SITE DEVELOPMENT PLAN

for BUNTING MULTIFAMILY FILING NO. 1, EL PASO COUNTY, COLORADO

Site Plan_V1_redlines.pdf Markup Summary

DP-1 MVE PROJECT 61072
MVE DRAWING -DEV-CS
EPC file no. PPR 17-037
July 30, 2018
SHEET 1 OF 2

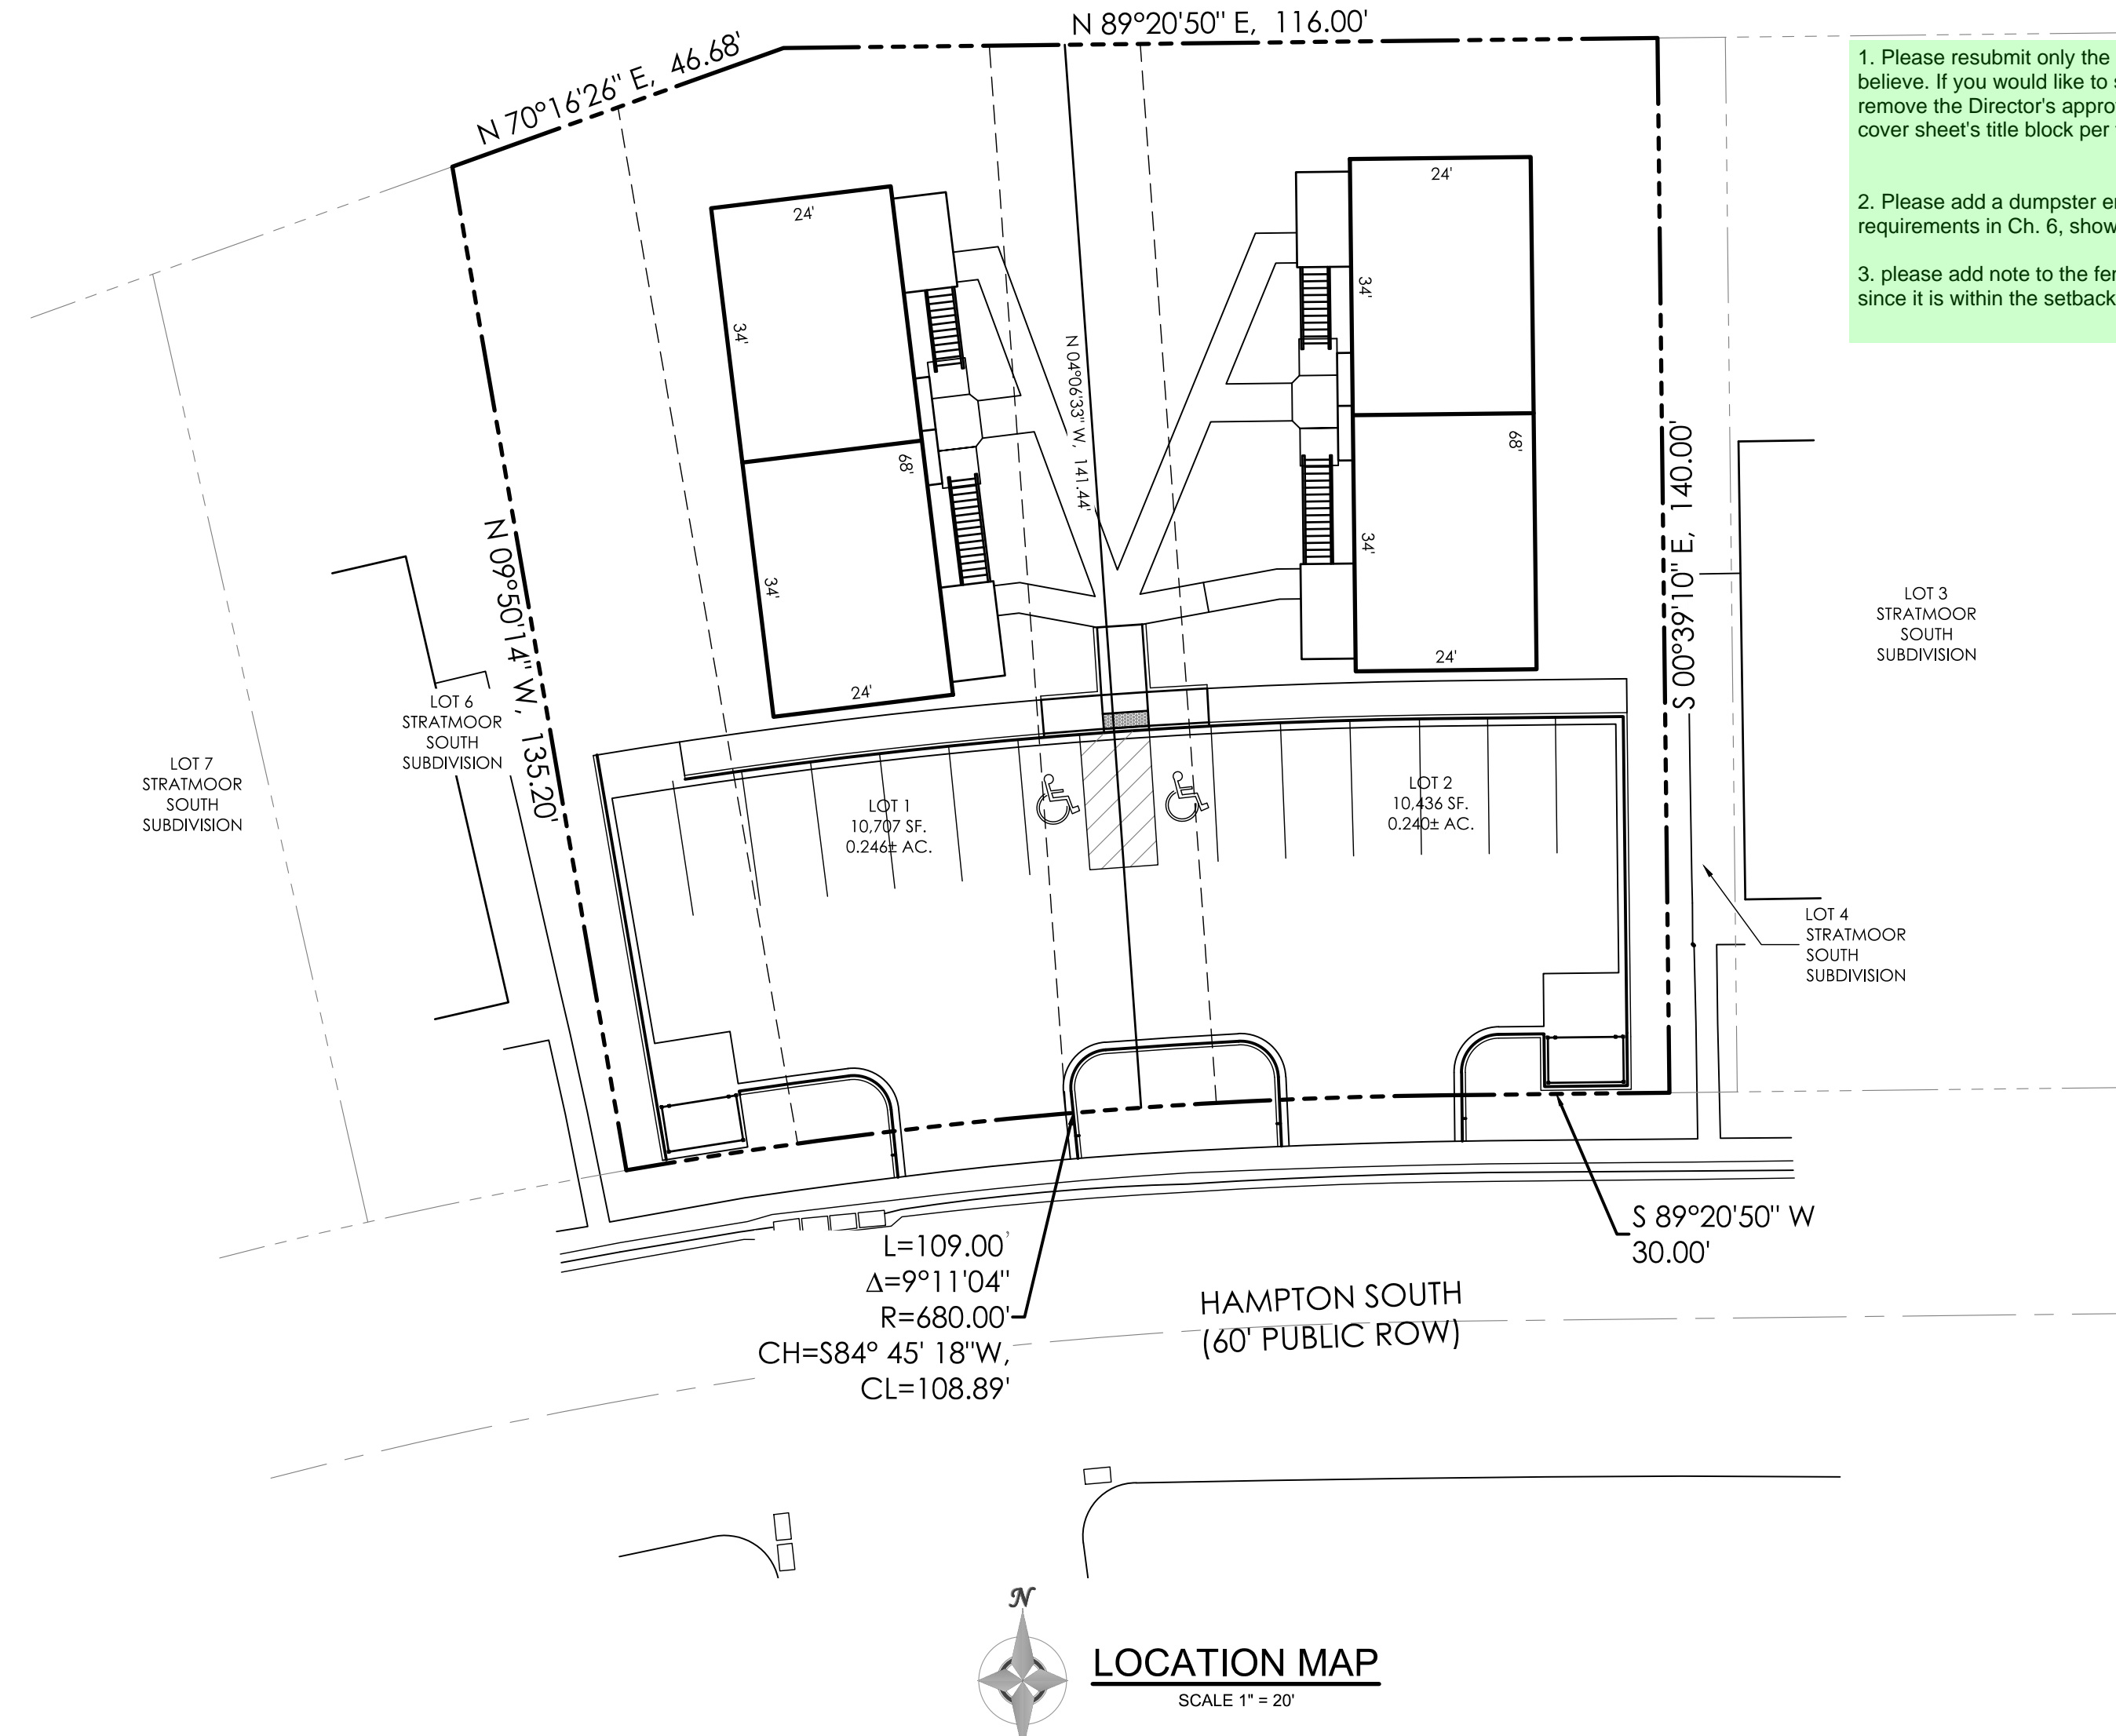
1. Please resubmit only the site plan sheet, which is the only affected sheet, I believe. If you would like to submit the whole packet again, then please remove the Director's approval stamp from this cover sheet and update the cover sheet's title block per the current date and COM 2116 project.

DP-2 MVE PROJECT 61072
MVE DRAWING -DEV-SP

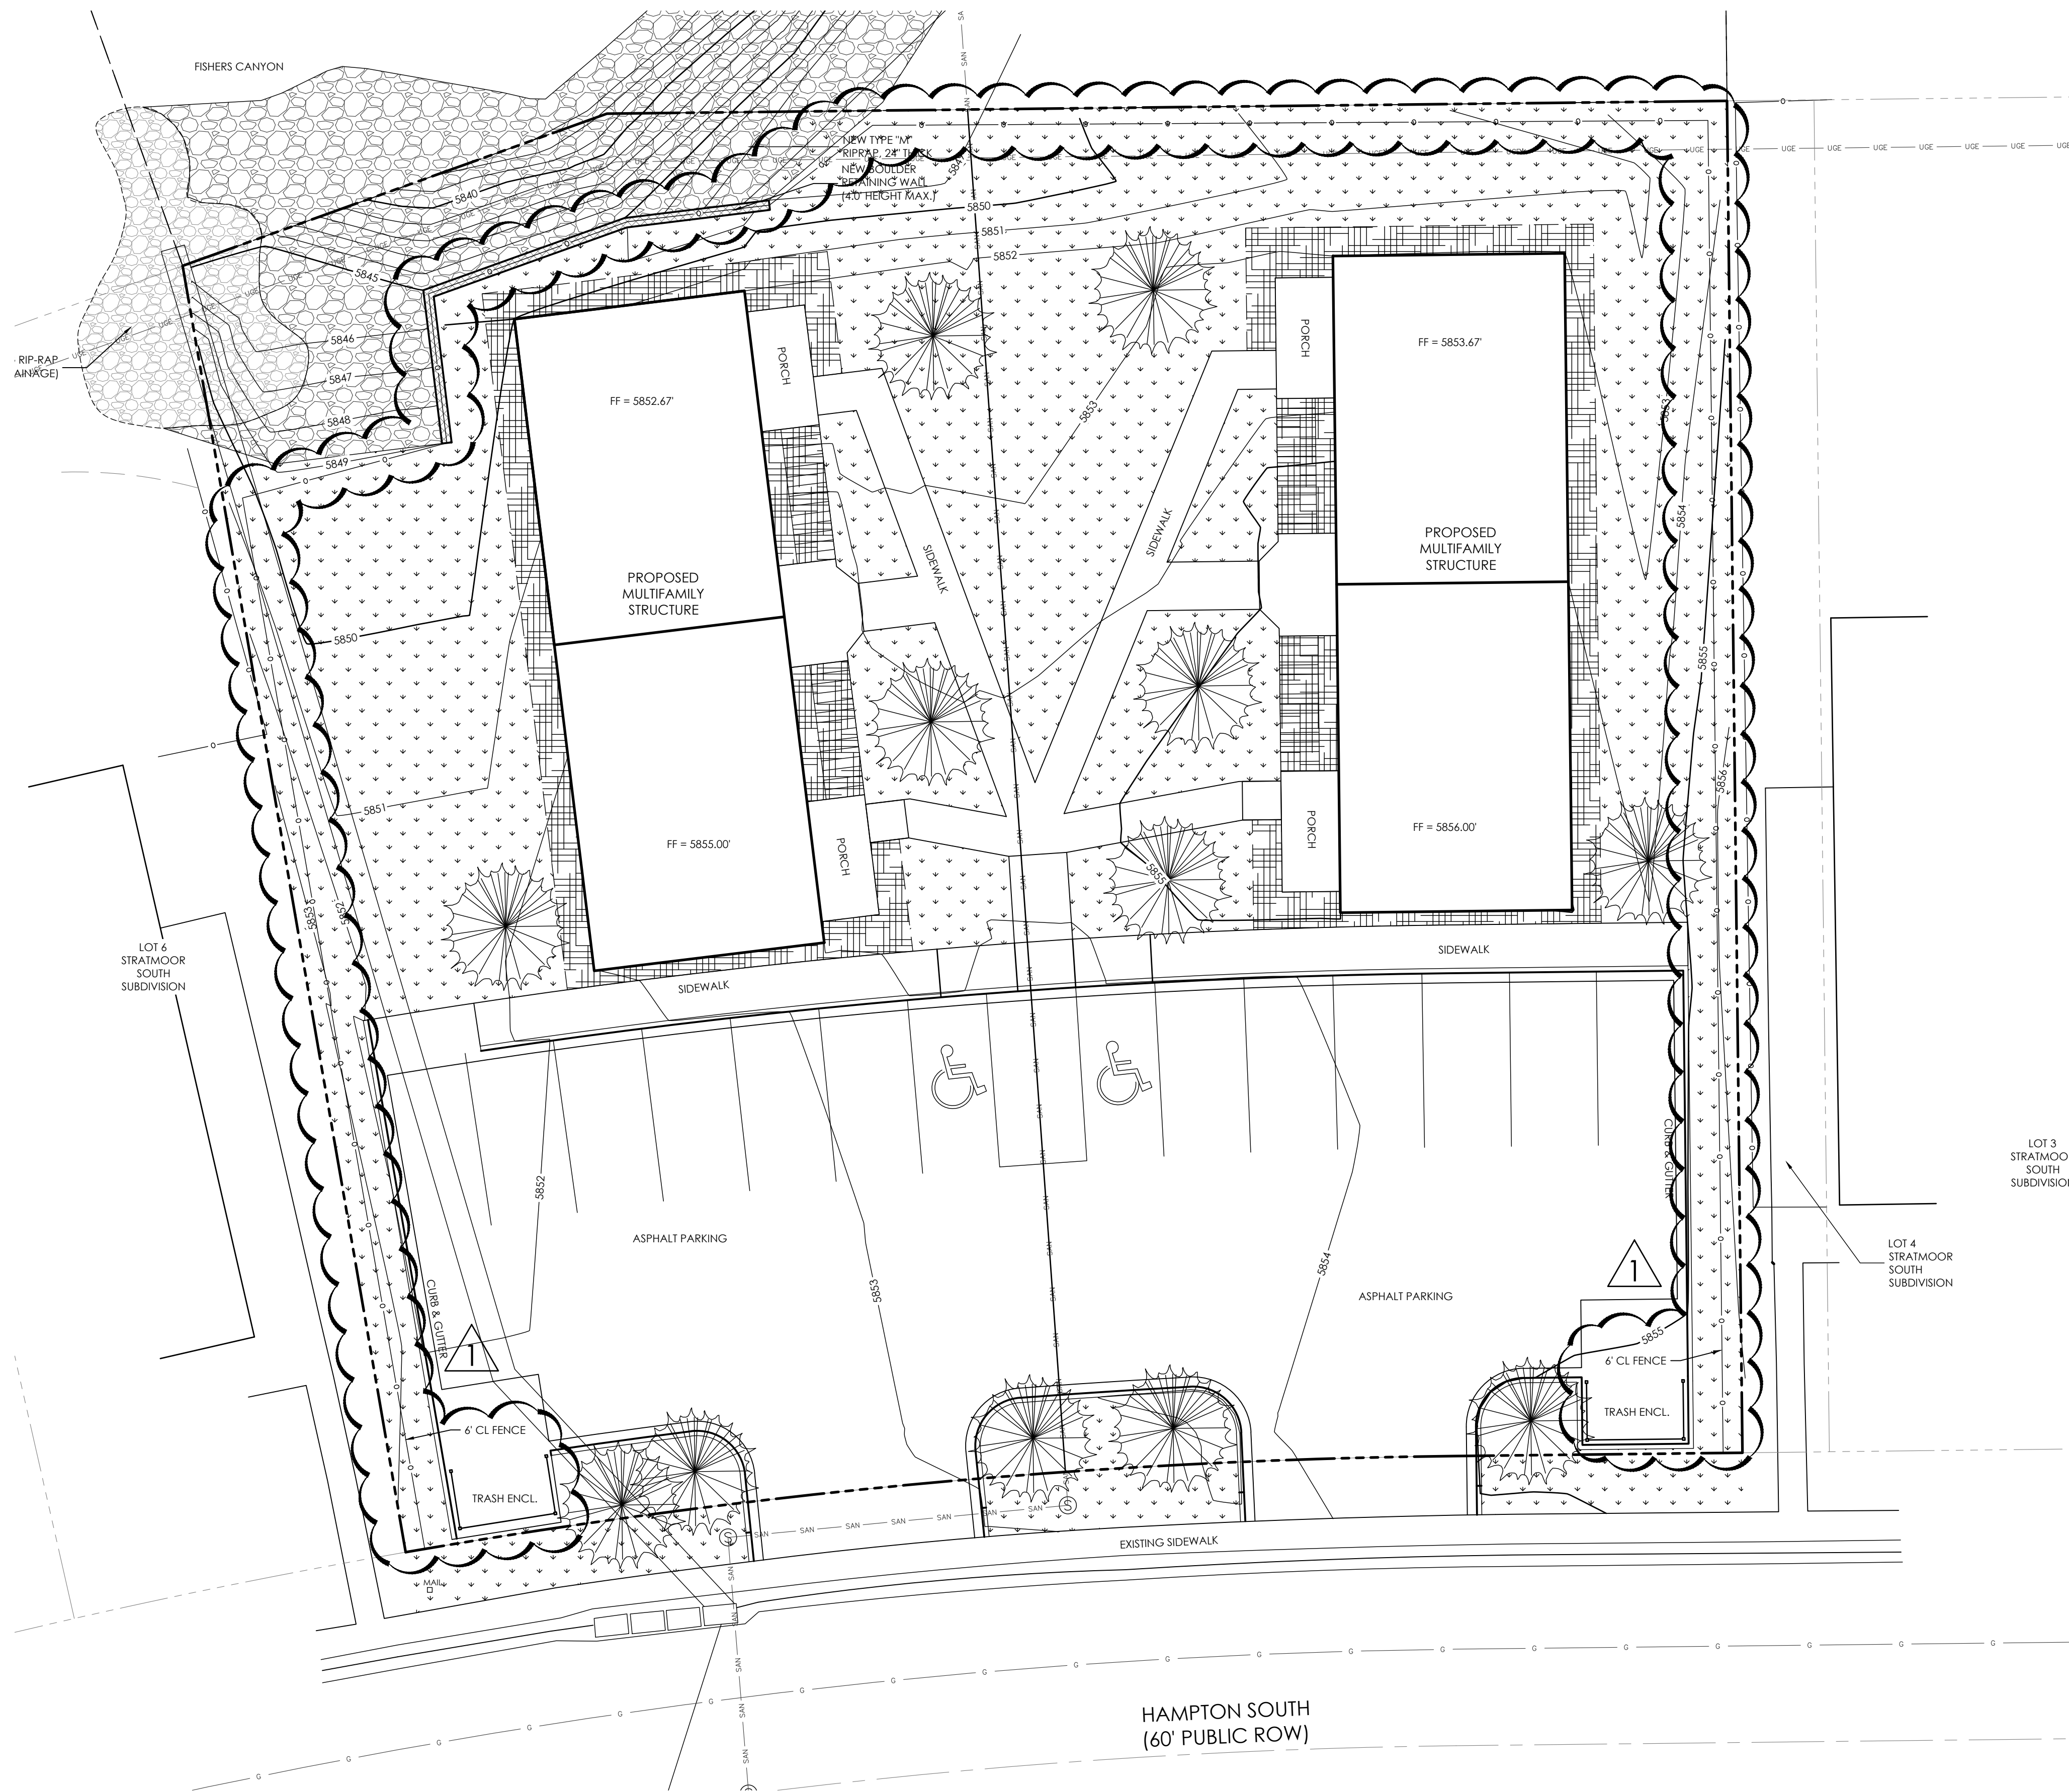
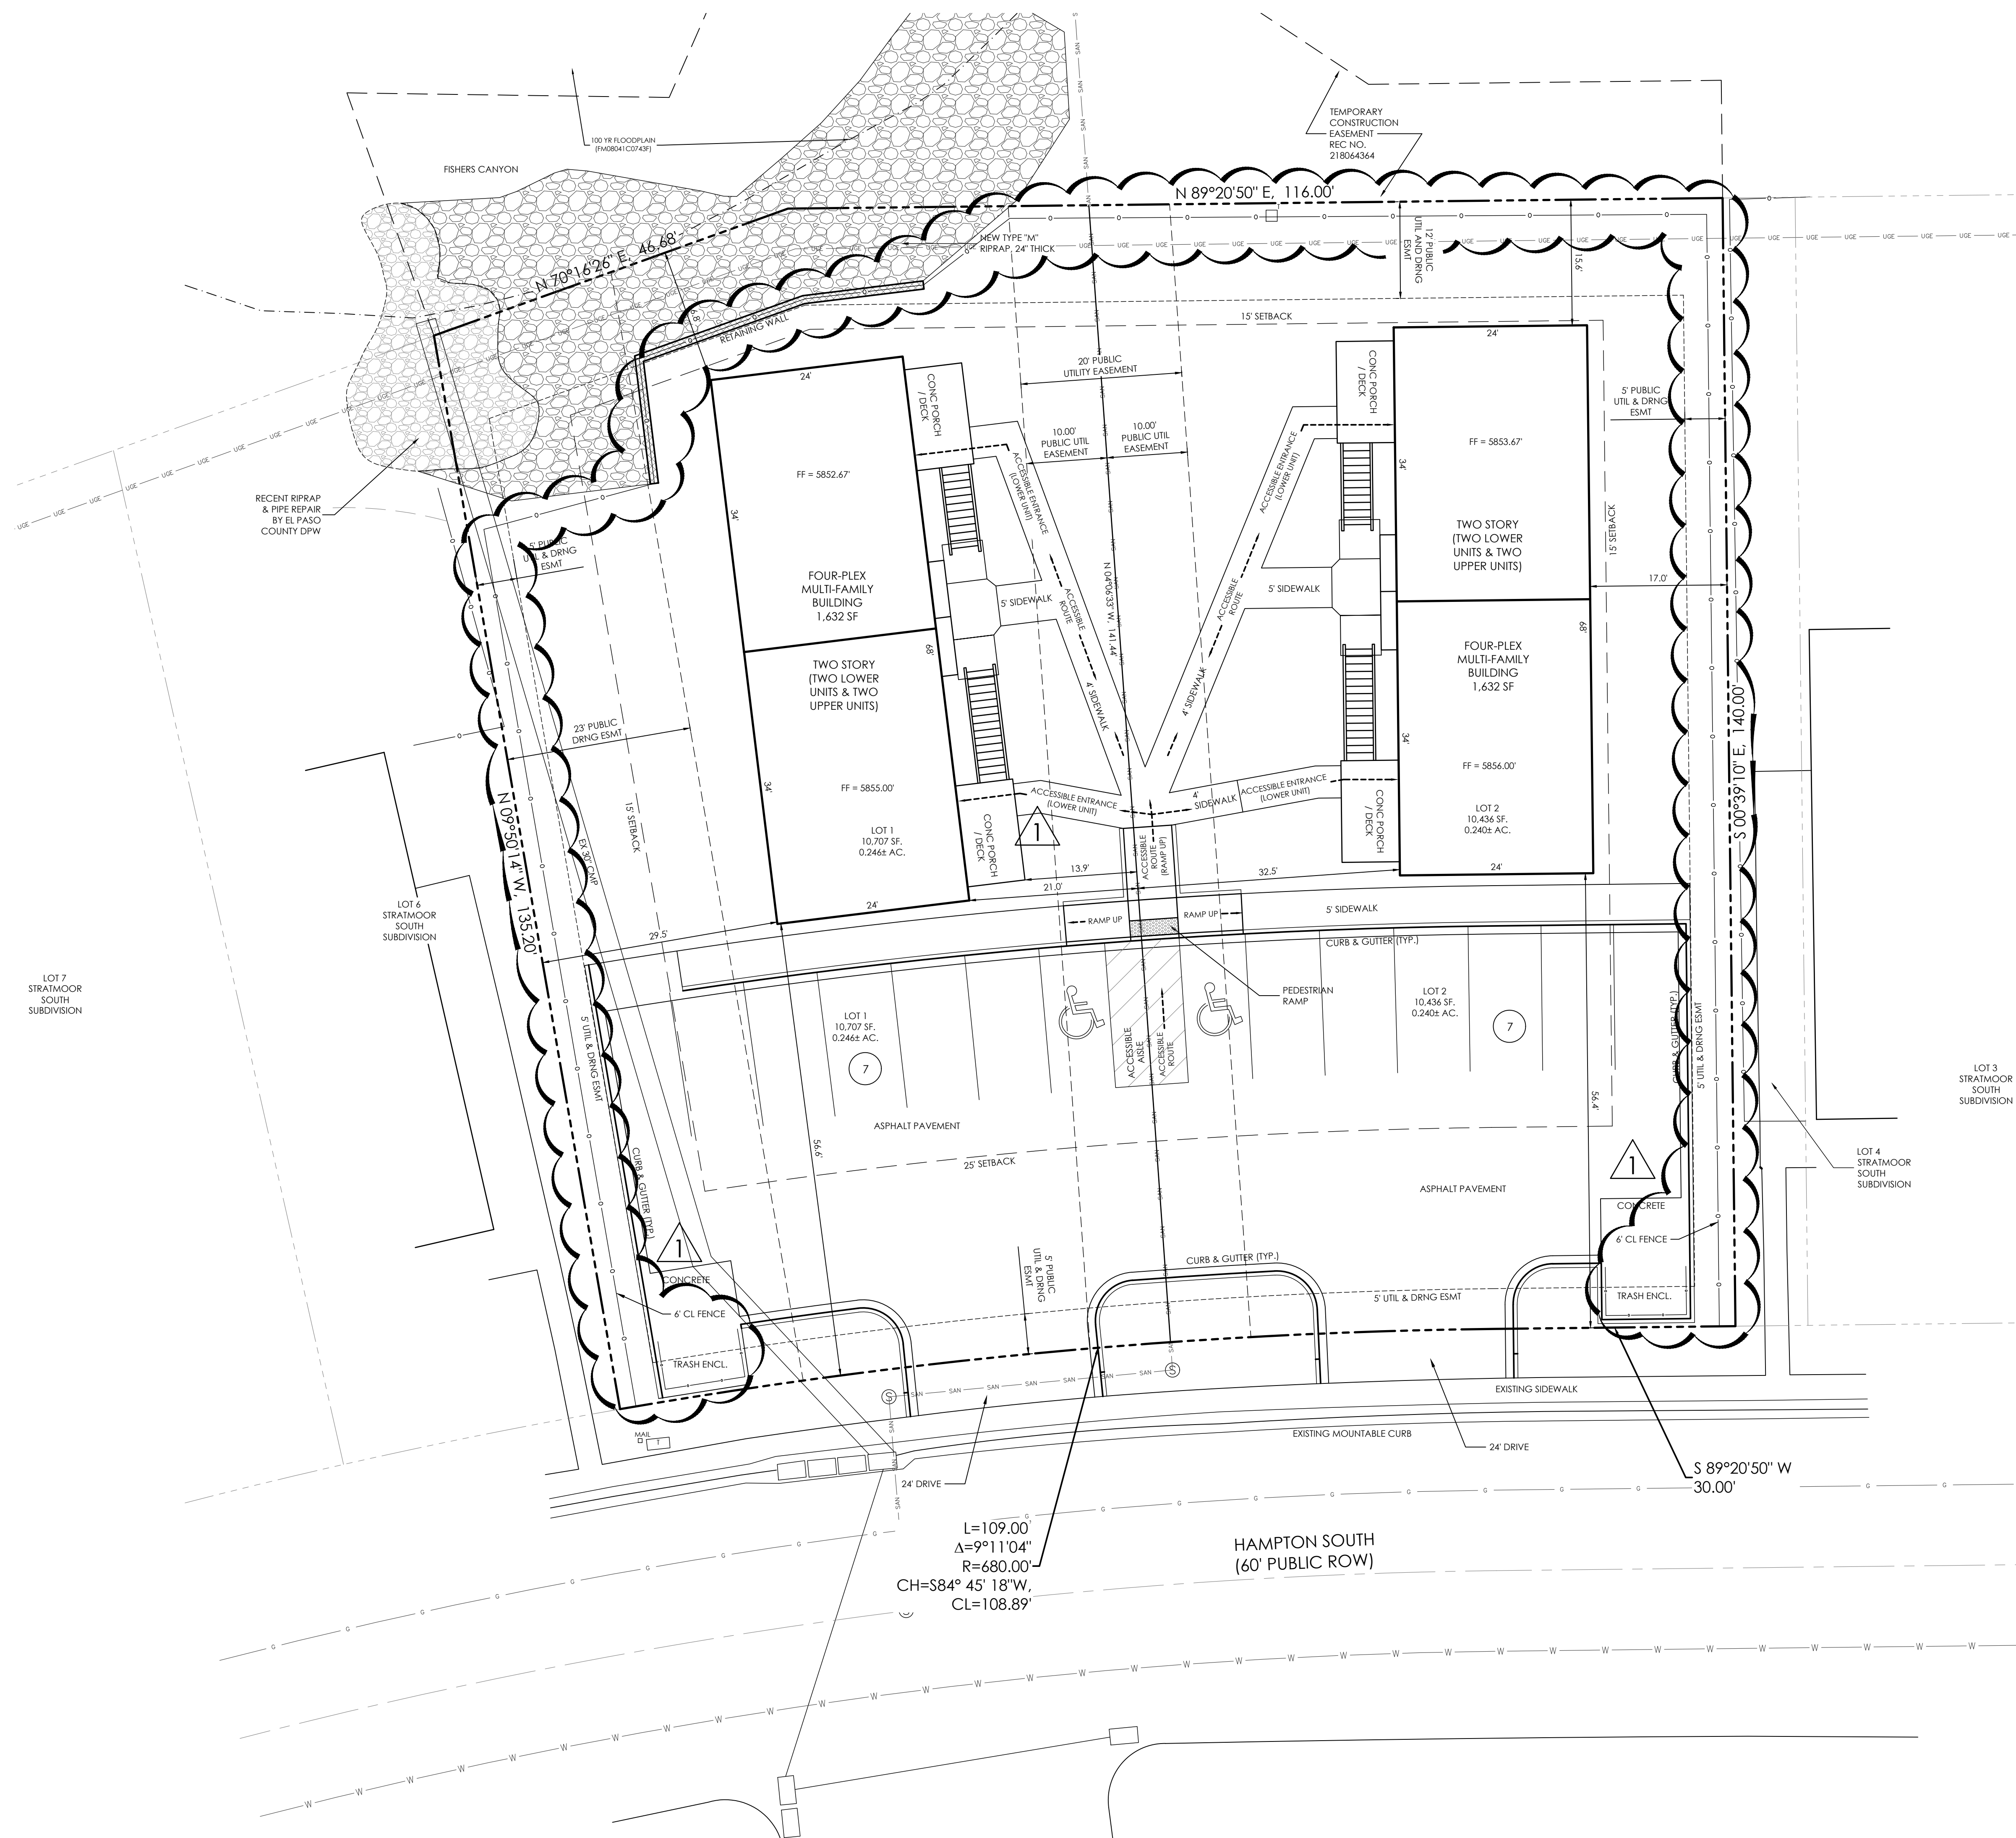
2. Please add a dumpster enclosure detail and ensure that it meets the requirements in Ch. 6, showing the type of screening material etc.

3. please add note to the fence detail confirming that it is an opaque fence, since it is within the setback.

REVISIONS
1) ADD PERIMETER CHAIN LINK FENCE & REV TRASH ENCLOSURE DETAIL 03/09/21
